# **VERIFICATION REPORT**

## **VE-UER-097-MP9.1**

«Recovery and Utilization of Associated Gas at Bukit Tua LPG Plant – PT. Arsynergy Resources»

For the period: 01/08/2022 to 31/12/2022

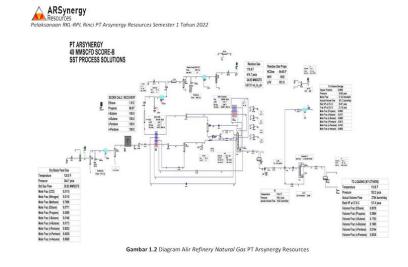
1.4. Are all GHG sources relevant to the project identified? Is any emission source missed? Check the site lay-out and confirm through site tour.

Project boundary is well identified all the GHG sources of the oil and gas separation facility and the processing station, such as the location of the Point F (delivery point) at the Bukit Tua oil and gas collection stations owned PT Petronas Carigali ,3km away from the LPG plant.

The other GHG sources outside the project boundary are also well established as illustrated in Section B.1 of the MR. The pipeline and all the infrastructures were on-site confirmed by the Lead auditor.

The diagram above was also checked against the managing plan of the project activity "RKL-RPL Rinci sem. 1 2022 final.pdf".
